Re: Former Chevron Service Station 209339
5940 College Avenue
Oakland, California
ACEHS Case No. RO0000466

Re: Response to Technical Comments and
Work Plan
Former Chevron Service Station 209339
5940 College Avenue
Oakland, California
ACEH Case RO0000466

ACEH's technical comments (in italics) and CRA's responses, as well as a work plan to address remaining data gaps, are provided below.

Figure 2 Site Plan

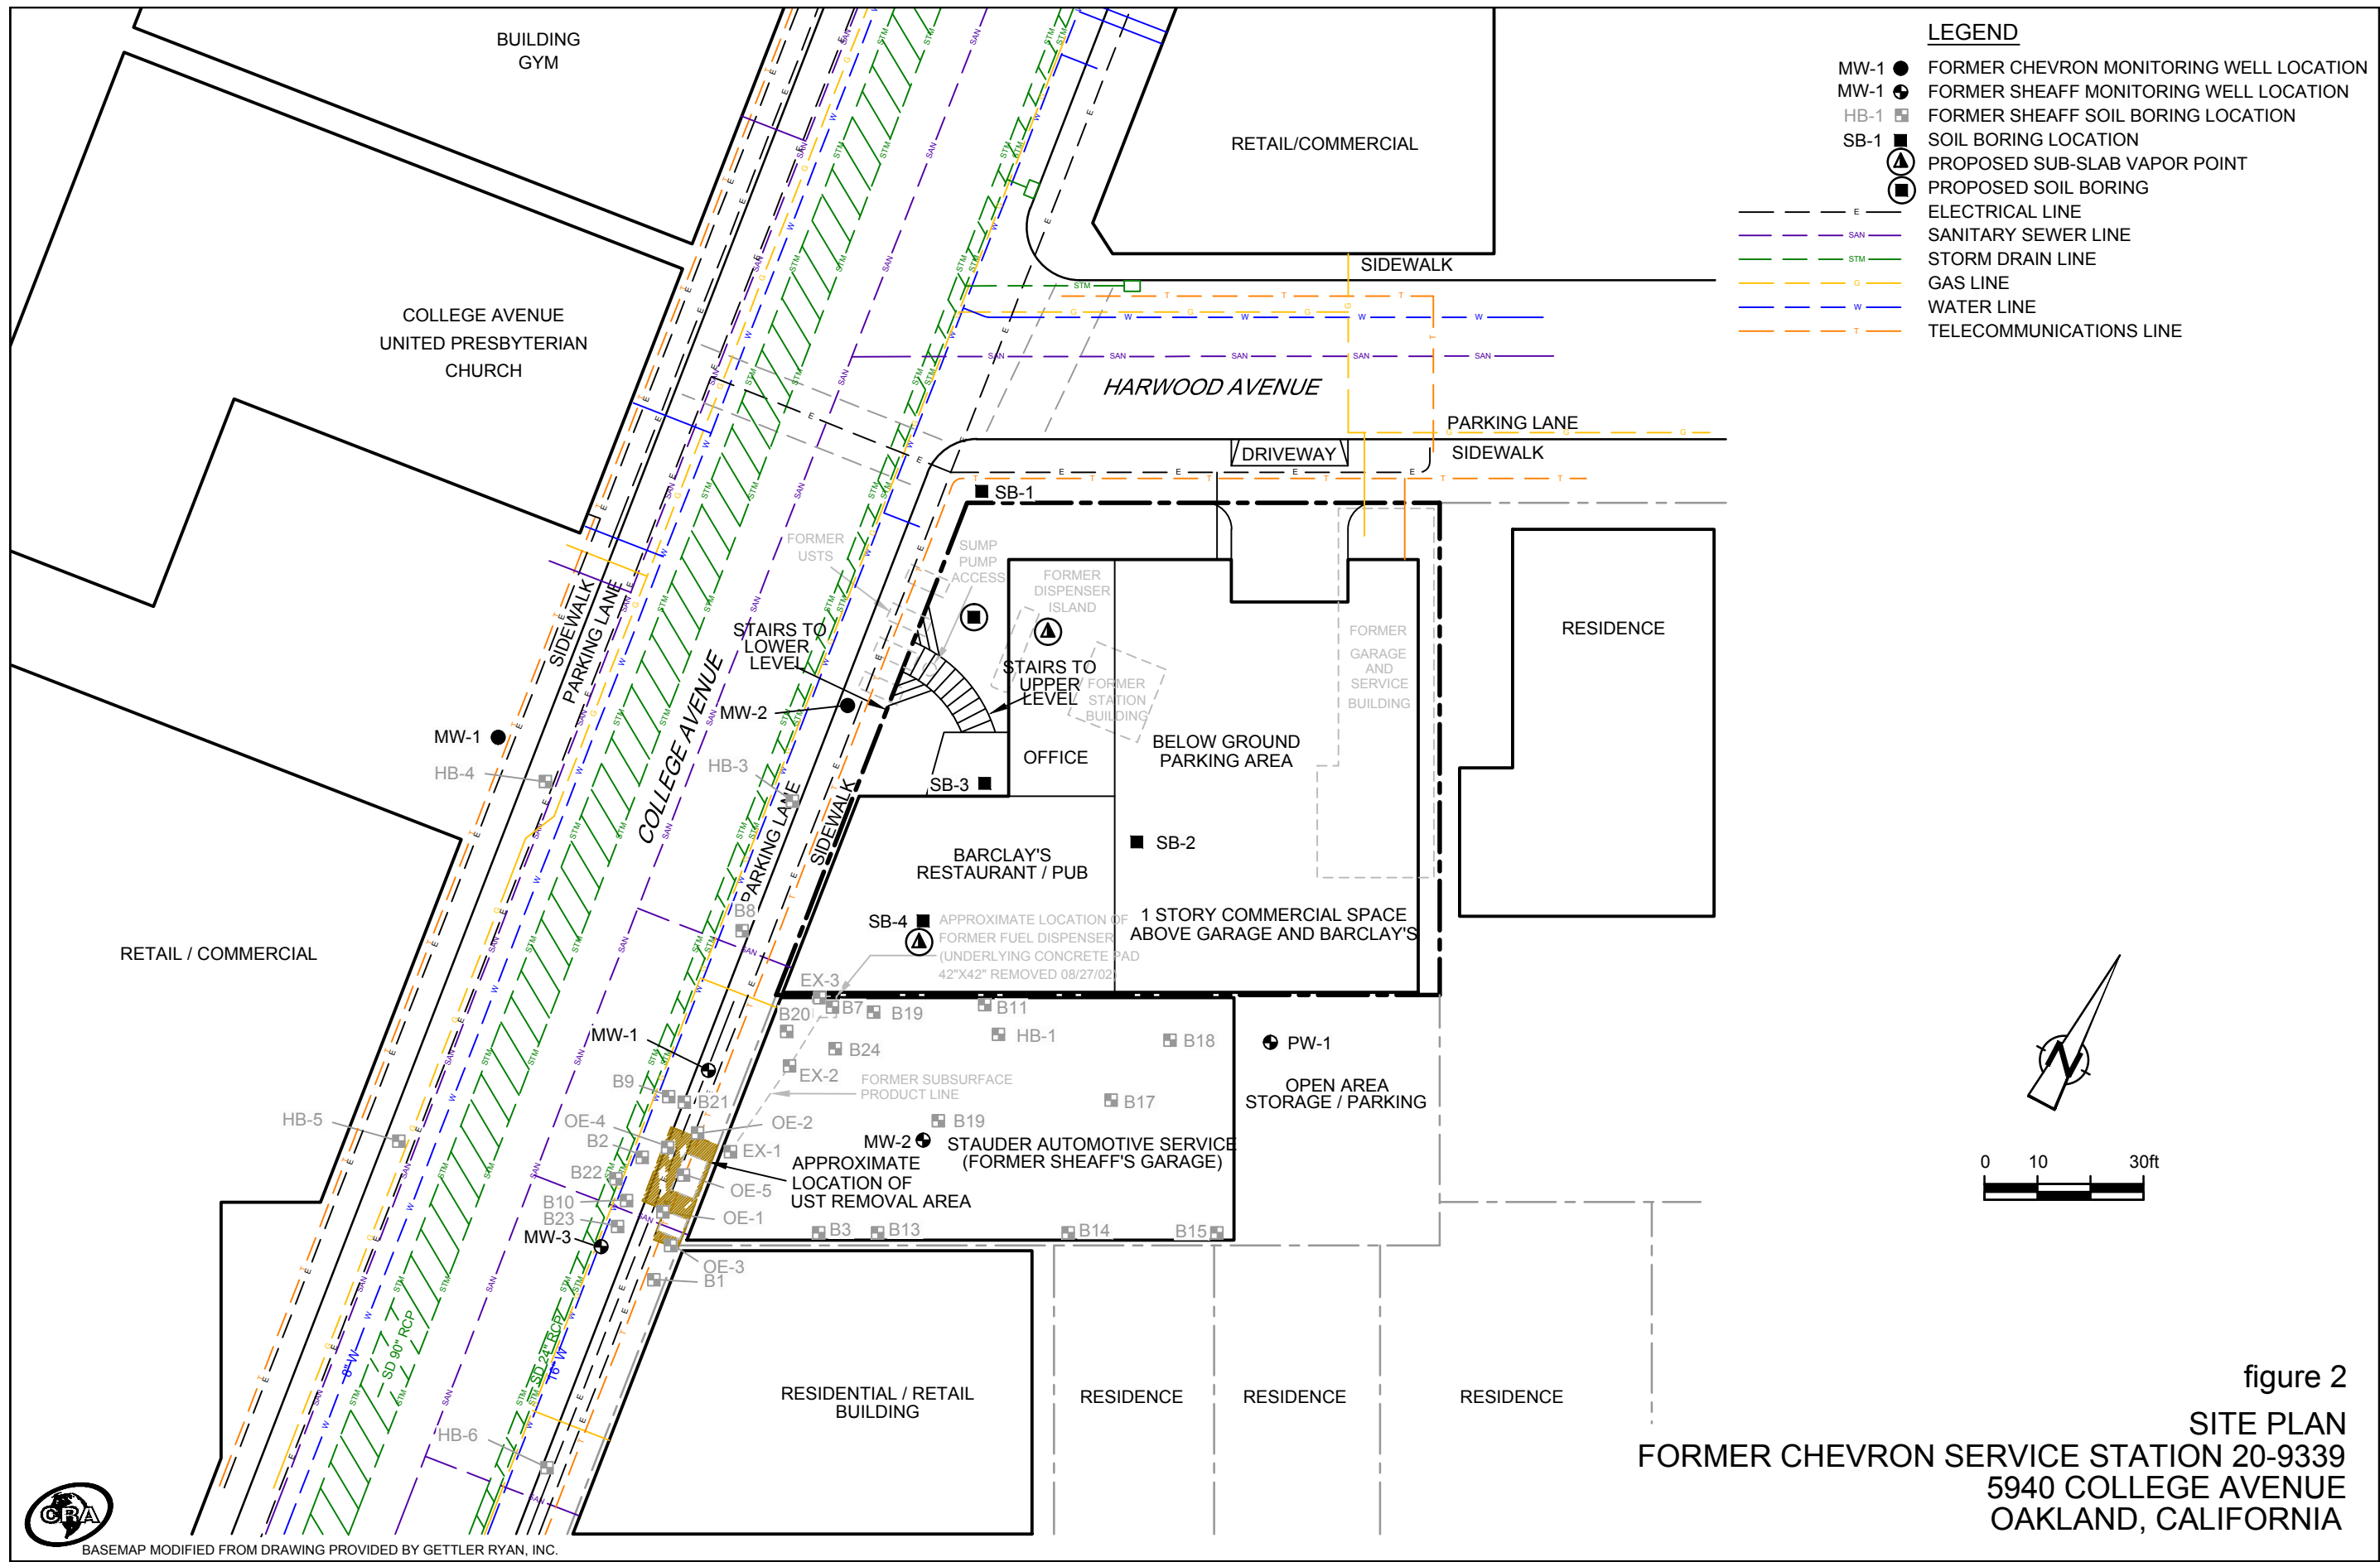
"...because naphthalene is present in both of these products, it would be appropriate to investigate residual soil contamination and determine the potential for the presence of SVOCs, including naphthalene, in any additional site investigation."

"...sample sump discharge (as a preferential pathway evaluation) beneath the stairway on the west side of the building."

“...the SCM did not address the risk of vapor intrusion at the site. Under the LTCP the vapor intrusion can be approached in three ways; groundwater concentrations coupled with sufficient soil analytical data, a risk assessment requiring sufficient analytical robustness, or direct sampling of soil vapor. There is insufficient data for each of these three approaches at this site.”

CRA proposes advancing a shallow soil boring in the area between the former USTs and dispenser island to collect a soil sample for naphthalene analysis (Figure 2). Further details are provided in the Work Plan and Schedule section below.

To address the vapor intrusion data gap, CRA proposes installation of two sub-slab vapor points and performance of an indoor and outdoor (ambient) air survey. One sub-slab vapor point would be located inside Barclay’s Restaurant (near SB-4) and the other inside the northwestern portion of the building near the former dispenser island (Figure 2). Further details are discussed in the Work Plan and Schedule section below.

The proposed sub-slab vapor points (Figure 2) will be installed using a rotary hammer drill to create a 1-inch deep "outer" hole that partially penetrates the concrete slab. A small portable vacuum cleaner will be used to remove cuttings from the hole. A smaller 5/16-inch diameter "inner" hole will then be advanced through the remainder of the concrete slab and into the substrate. The sub-slab vapor probes will be constructed using stainless steel tubing and compression fittings to ensure that construction materials were not a potential source of volatile organic compounds (VOCs). The probes will be set in the holes and completed flush with the slab. Cement grout will be placed into the annular space between the probe and the edge of the "outer" hole and allowed to cure for a minimum of one week before sampling. A schedule will be provided for this activity after the access agreement is in place.

The proposed boring (Figure 2) will be advanced with a hand auger to 5 fbg and the soil cuttings will be logged and screened with a PID. A slide hammer will be used to collect a relatively undisturbed soil sample in a brass or stainless steel sleeve. The sample will be capped with Teflon squares and plastic end caps, labeled, placed on ice, and shipped under COC protocol to a state-certified analytical laboratory where it will be analyzed for naphthalene by EPA Method 8270. A schedule will be provided for this activity after the access agreement is in place.
